Access Compliance Report

Public Rights-of-Way

(Pedestrian Signals)

Intersection ID: N/A	Main Street:	Cross Street: N/A	Location: N/A
ADA ID: CCB9B221EF24	Signal Type: One Push Button-Non APS	Overall Compliance: No	Severity Score: BTN 1: N/A BTN 2: N/A No BTN: N/A
Codes/Mitigation Info/Possible Solution		Field Measurements/Component Compliance

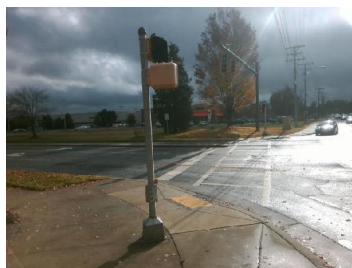
PROW/ADA: TMUTCD 4e.08, R404.2, R404.3

Yes	B 1 Clear Xing Direction?	ClearlyMarked	N/A	B 2 Clear Xing Direction?	N/A
	B 1 Crossing Direction	To SW		B 2 Crossing Direction	N/A
Yes	B 1 DistanceTo XWalk (in)	0.0	N/A	B 2 DistanceTo XWalk (in)	N/A
No	B 1 DistanceTo Curb (in)	83.0	N/A	B 2 DistanceTo Curb (in)	N/A
Yes	B 1 Diameter (in)	2.0	N/A	B 2 Diameter (in)	N/A

Possible Solutions: Replace Signal Push Button With APS Button on New Post. Remove & Relocate Sign.
